Appl. No. 10/790,844
Amdt dated January 20, 2006
In Reply to Office Action dated September 21, 2005

Amendments to the Drawings:

Fig. 1

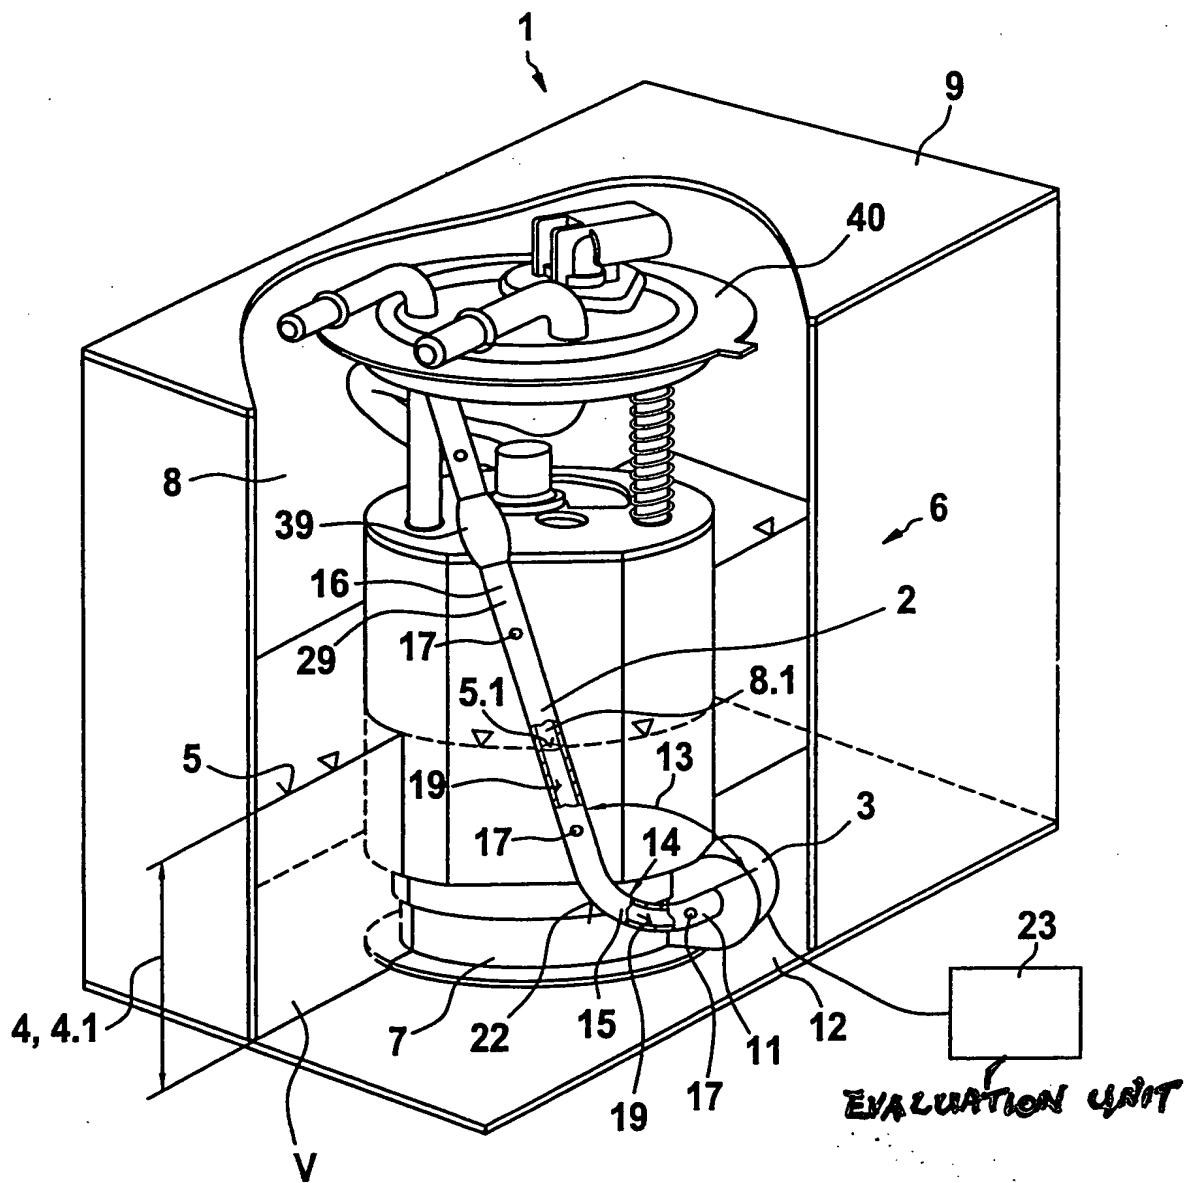
The two attached sheets of drawings include changes to Figs. 1 and 2 and replace the original sheets including Figs. 1 and 2. In Figs. 1 and 2, the label "evaluation unit" has been added to box 23.

Figs. 1 and 2 of the drawings have been corrected to add the label "evaluation unit" to box 23. The claims have also been amended to change reference numeral "18" to read "6." The specification, including the claims, no longer refers to reference numeral 18. In view of the preceding, withdrawal of the objection to the drawings is requested.
